**RE: Industrial Emissions Activities Licence Application for Timoleague Agri Gen Ltd.,
Barryshall, Timoleague, Bandon, Co. Cork. Reg. No: P0986-01.**

I refer to your letter requesting clarification of further information dated 03 March 2014 in relation to the above Industrial Emissions Activities Licence Application for Timoleague Agri Gen Ltd.

Figure 9 Fully enclosed slurry storage in earth shape with 1mm reinforced PVC lining
(drawing courtesy of www.steenbergen.org)

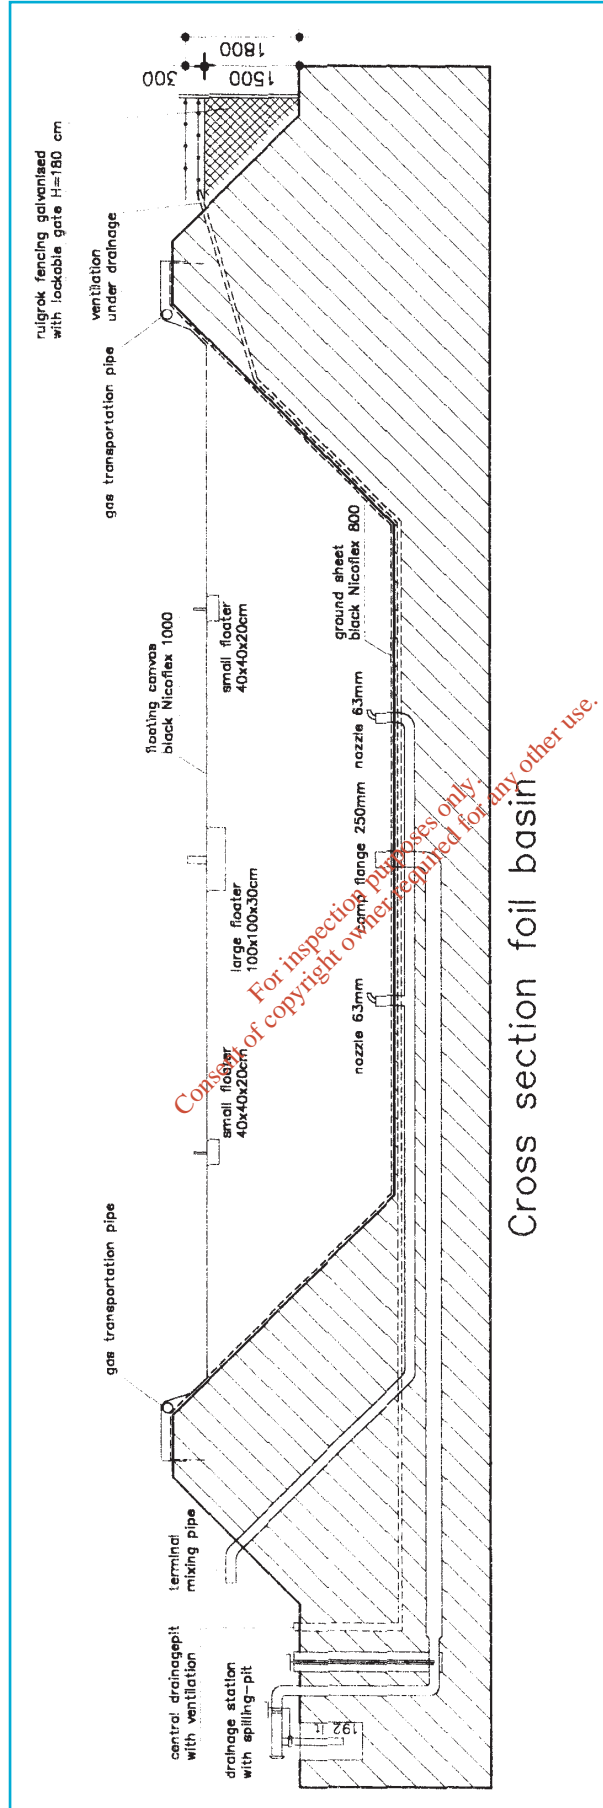
9. Drawing Number 19 indicates that there are vents in the floating covers of the geomembrane lined manure basins. Confirm how the floating cover and vents prevent odour emissions.

The Geo-membrane lined manure basins will be built as per Odournet UK 2001's report **“Odour Impacts and Odour Emission Control Measures for Intensive Agriculture - Part A Odour annoyance assessment and criteria for intensive livestock production in Ireland”**. Attached is a drawing, sourced from Odournet UK, of the proposed Geo-Membrane Lined Basin.

Floats support the cover, and an extraction system for escaping digestion gas is provided in the design. They are made out of reinforced plastic (PVC) foil of 1 mm thick (see Figure 9). Stirring of the slurry is achieved through pumping slurry through a specially designed fixed tubing system. These fully enclosed foil basins have an economic lifespan of at least ten years.
